**Re: *Reliability and Resource Adequacy Study Review – Updated Project Schedule for L'Anse au Diable Grounding Station and Wave Study for Dowden's Point Grounding Station***

## Design Check Report

Dowden's Point Breakwater

**Figure 1 – 2010 Preliminary Breakwater Design**

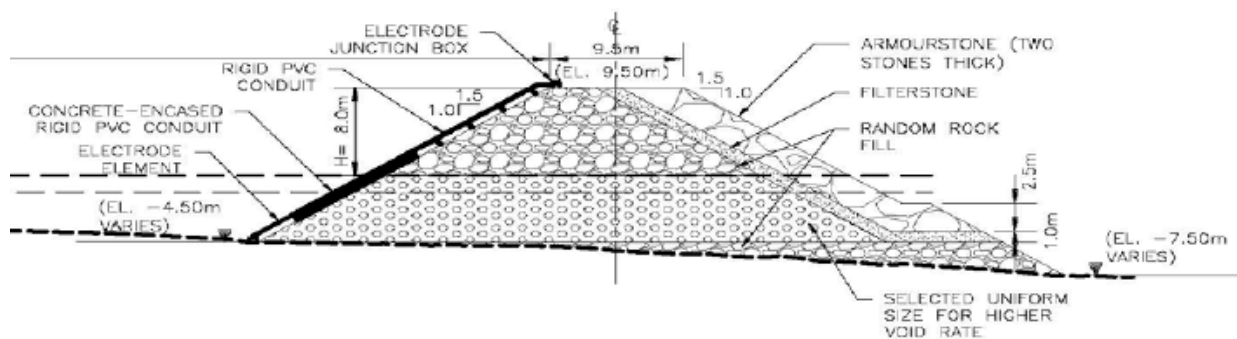
2010 preliminary Dowden's Point Breakwater Designs detail a crest height of 9.50m. It is assumed that this is referenced to chart datum which would equate to 8.75m geodetic. A 2010 cross section is shown below:

**Figure 2 – 2015 Issued for Construction Breakwater Design**

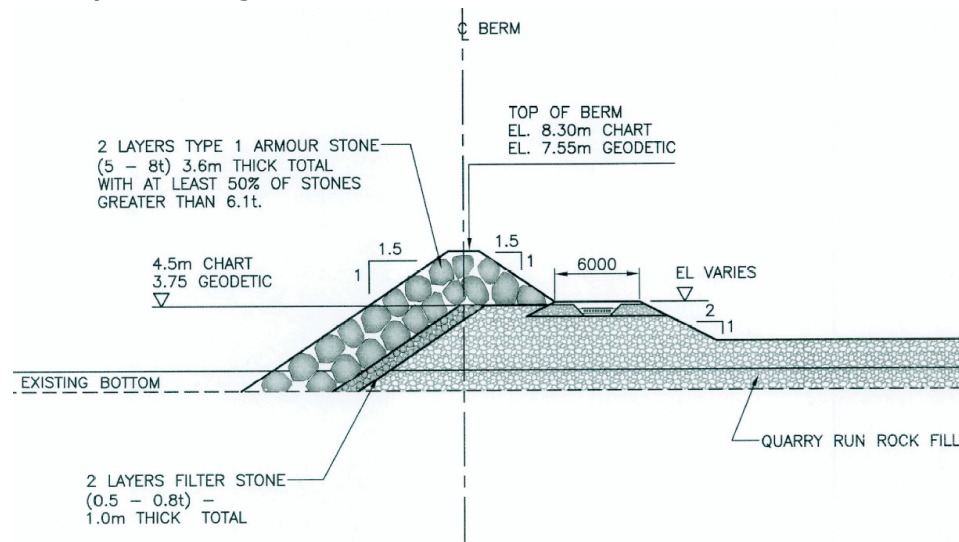
Based on the 2012 Design Criteria, the 2015 Issued for Construction Design defines a 7.55m (geodetic) crest height as can be seen below:

**Figure 3 – 2016 As-Built Breakwater Survey**

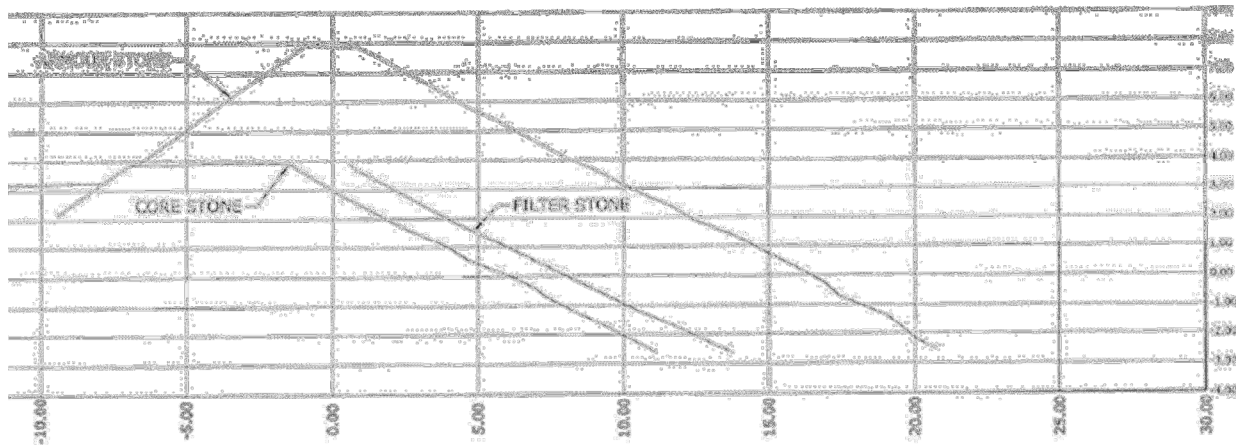
As-built surveys performed and verified after construction show a consistent crest elevation over the length of the structure of approximately 7.8m geodetic. A sample of the as-built survey results is shown below:

Table 5 below summarizes the design and as-built crest elevations:
